**FINAL DRAINAGE REPORT
FOR
SOLACE AT CIMARRON HILLS**

**May 16, 2021
Project No. 25174.00**

**PCD File No. PPR-20-047
PCD File No. SF2032**

Figure 8-22. Swale stability chart; 2- to 4-foot bottom width and 10:1

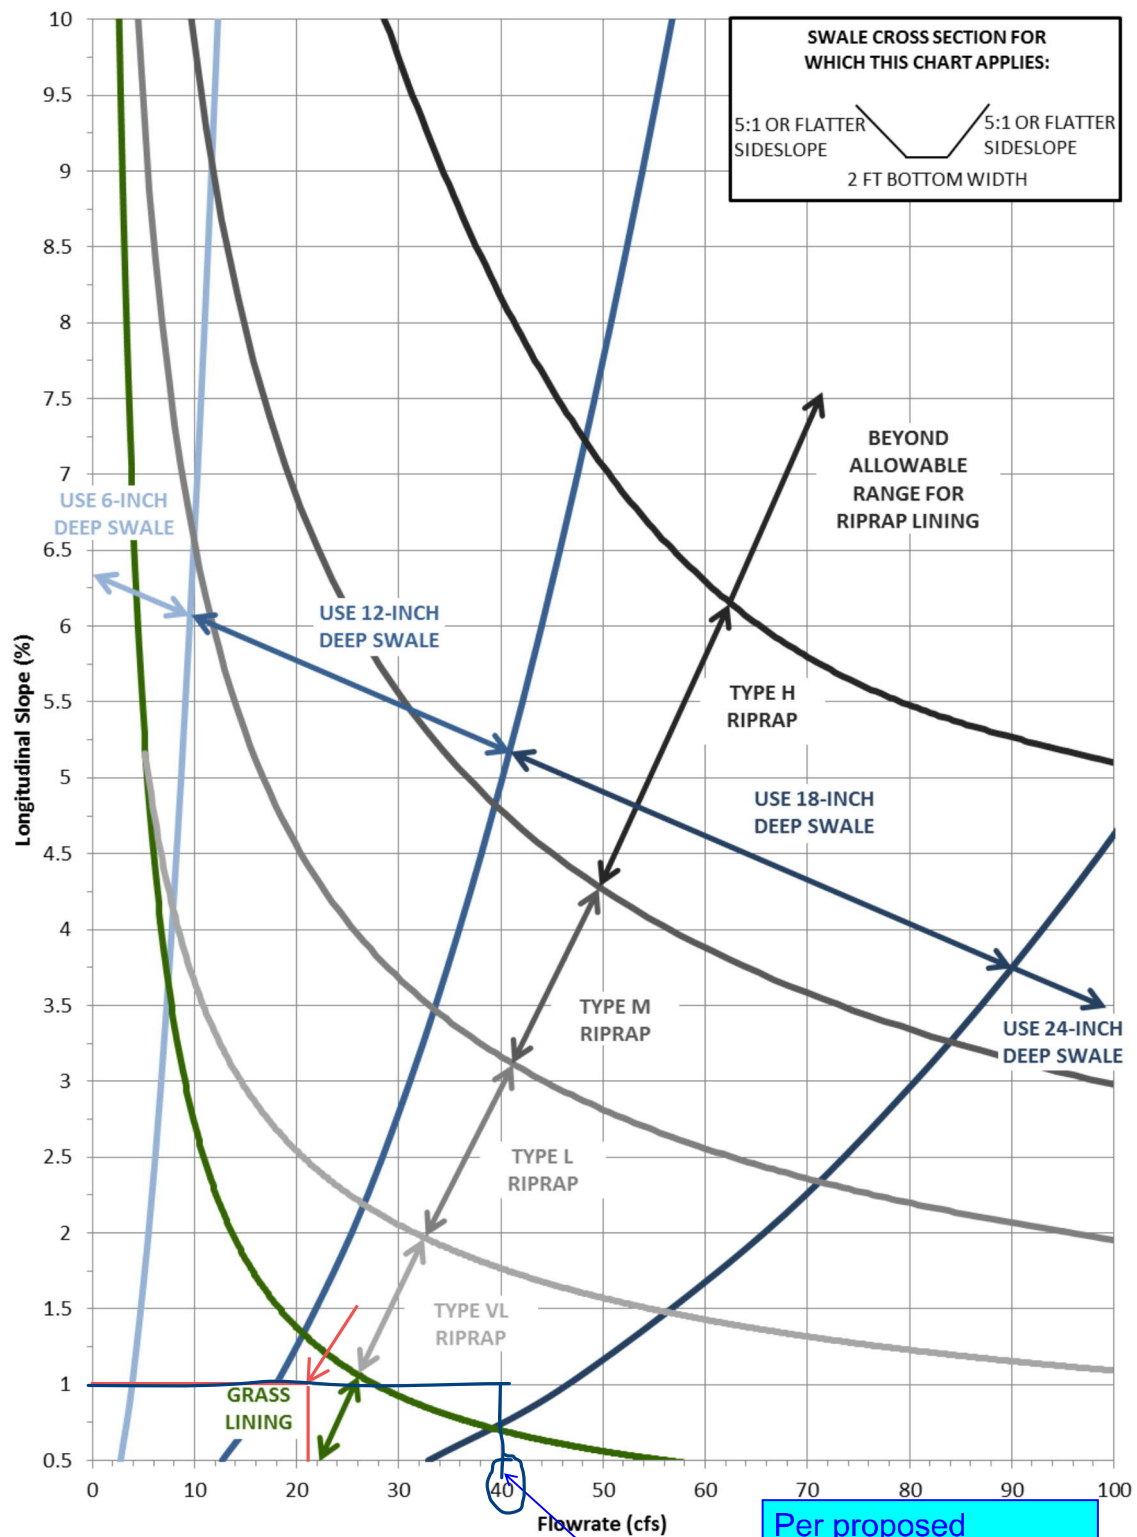
Per UDFCD figure 8-22, 100-year runoff values would require type VL riprap. Please address this and upgrade recommendation if necessary.

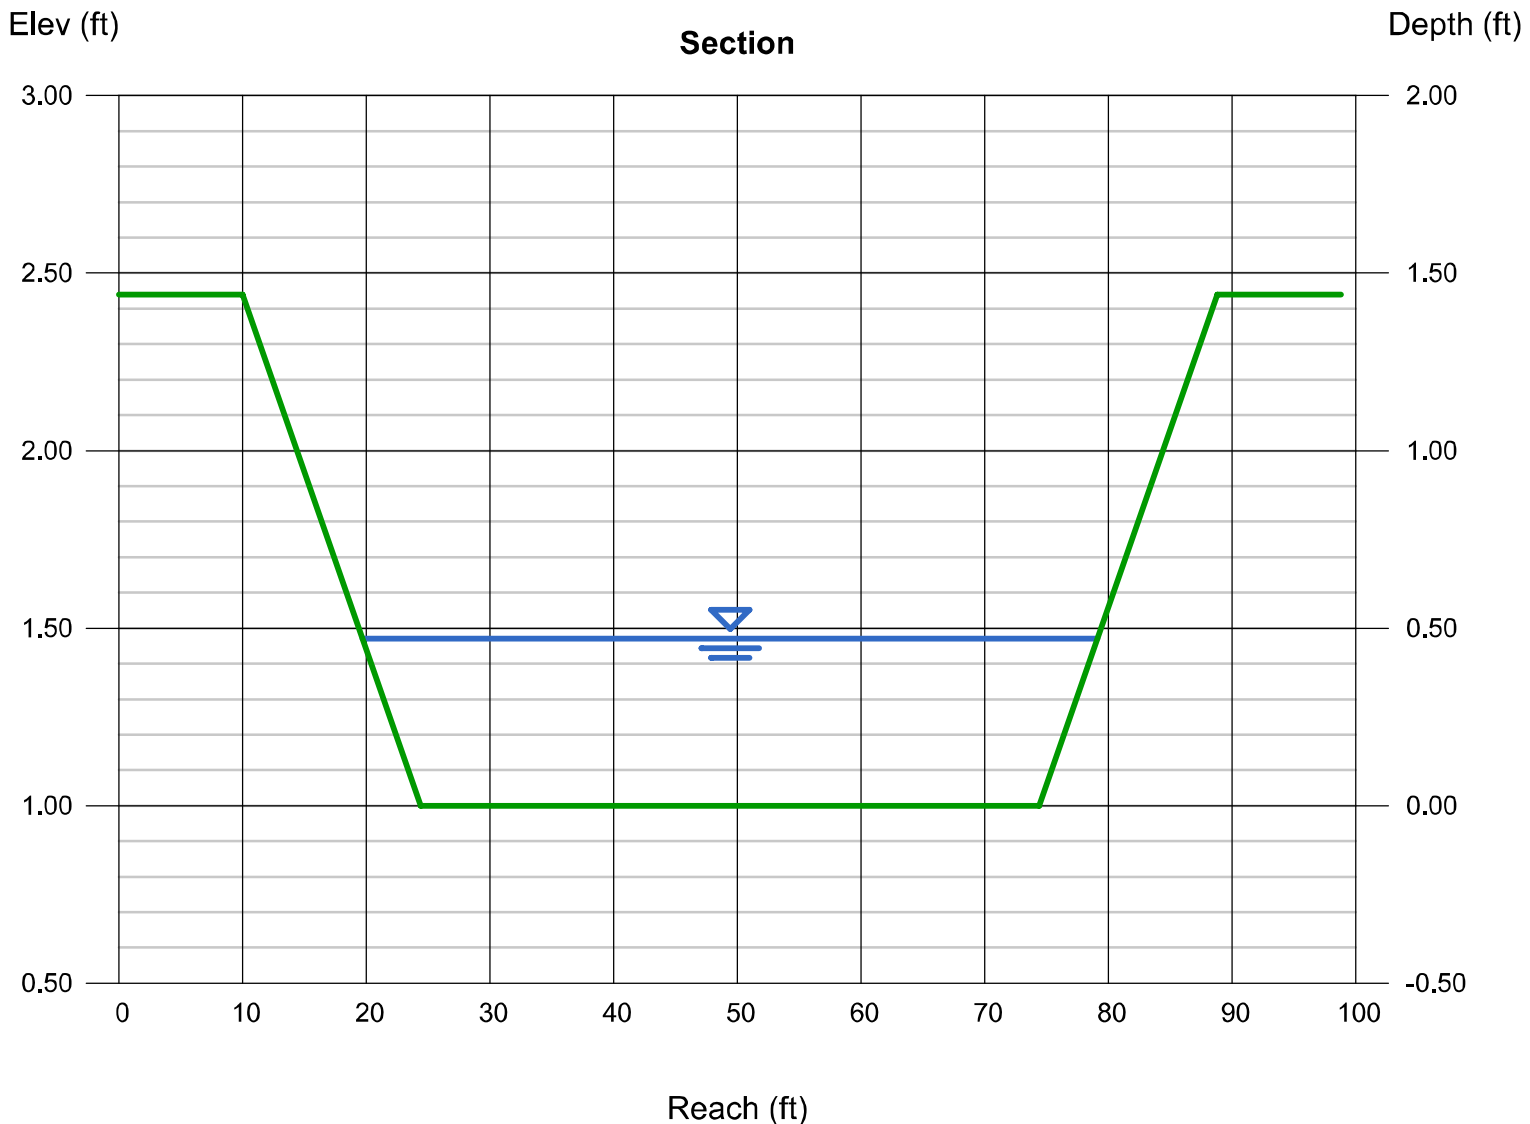
Please provide pond
b spillway
calculations.

Pond B spillway calculations
added to appendix
